SUBJECT: Freeport Harbor Channel Improvement Project (FHCIP) Final Feasibility Report and EIS (September 2012) – Documentation of Review Findings

DOCUMENTATION OF REVIEW FINDINGS

FREEPORT HARBOR CHANNEL IMPROVEMENT PROJECT

**Final Feasibility Report and
Environmental Impact Statement**

Figure 1a
 Effective Water Depth
 Freeport Harbor Channel
 Mean Low Tide – Mean Low Low Water

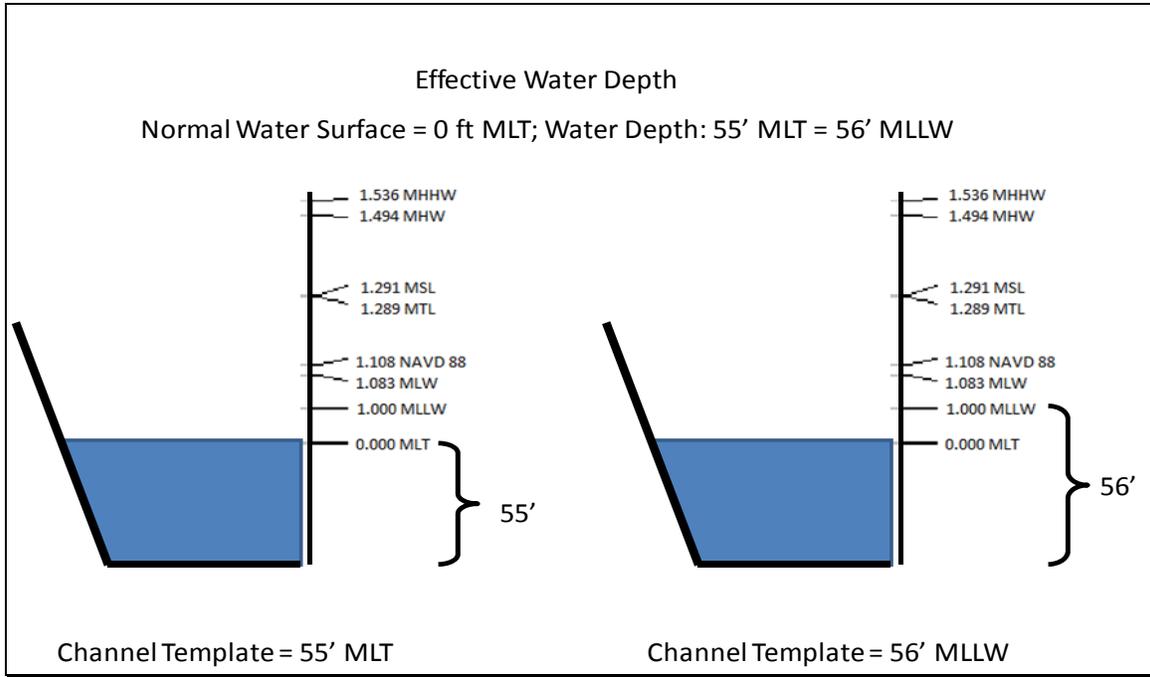
HQUSACE Preliminary Assessment (21 April 2011): The concern has not been resolved. It is not clear that the appropriate blended cost sharing is being done based on the cost sharing change at a 20 and 45 foot depth MLLW. Based on the SWD emails from 4/26 this may result in a minor change to cost sharing for the Lower Stauffer as shown in Table 96. The Freeport channel cost sharing would not be affected since the depths are above 45 feet MLLW. However, Table 95 is showing 50%/50% cost sharing (\$134,181,500 each) for the Freeport channel. It appears these numbers are incorrectly including the associated costs for GNF cost sharing since the costs total \$281,943,000 at the bottom. The difference in total Federal and non-Federal cost shares as

shown appears to be predominantly due to the adjustment for an additional 10% non-Federal contribution required over time. This type calculation relates only with GNF and LERR costs and associated costs should not be included. Also, the text in Section 14.1 still indicates that the conversion to MLLW is being deferred to PED. Depths in the recommended plan description are still shown relative to MLT and need to be shown in MLLW.

HQUSACE Assessment (May 2011): The concern is not yet resolved. The explanation of the conversion between MLT and MLLW datum has been included in the text at appropriate locations. However, the text in the project description/recommendations, Executive Summary, Introduction and Engineering Appendix need to show the recommended plan depths in MLLW as will be cited in the Chief's Report. Blended cost sharing needs to be shown relative to the project depths in MLLW. It is acceptable to reference the project depths in MLT followed by MLLW depths in parentheses. All references to datum conversion during PED should be removed as noted in the preliminary response above.

Action Required: Revise the text of the final report to show the recommended project depths at key locations in MLLW in addition the MLT including Executive Summary, Introduction, cost sharing section, Table 93, and Engineering Appendix. Delete references to datum conversion during PED. Adjust prorating for blended cost sharing to account for the project costs at MLLW depths.

SWG Preliminary Response (2 May 2011): This concern was previously raised and evaluated by the vertical team. After sharing of information with the entire team a teleconference was held in February 2011. The Galveston District detailed three alternative means to address the issue. These ranged from no changes in the report to full reformulation based on a changed datum. After discussion the team agreed to include information on how the change in datum impacts the information in the report but the specific information in the report would remain as is. Galveston detailed the datum information in several places throughout the report as specified by HQ. The draft Chief's Report will be submitted with all numbers in MLLW. It was our understanding that no additional changes were necessary. The bridge between the Feasibility Report and the Chief's Report was noted in the teleconference to be the discussion about the relationship between MLT and MLLW in the Feasibility Report. All references in the Feasibility Report to conversion to MLLW in PED will be removed.

District Action: The main report has been modified to address the comment. The Executive Summary, Introduction, Engineering Studies (Section 8, Main Report), and Plan Selection portions of the main report have been modified. Table 93 has been modified to include MLLW and cost shares detailed in Section 12 have been modified so that they are apportioned to depths in MLLW. Section 14.1 has been revised to delete conversion to MLLW being deferred to PED. The following information has been modified/included in the report.

At Freeport Channel, datum values for MLLW are +1 foot above MLT. However, this does not result in increased water depth, as the additional +1 foot of nominal depth is actually +1 foot above the normal surface water level. Therefore, the actual water depths are equivalent between a 55 feet MLT channel template and a 56 feet MLLW channel template.
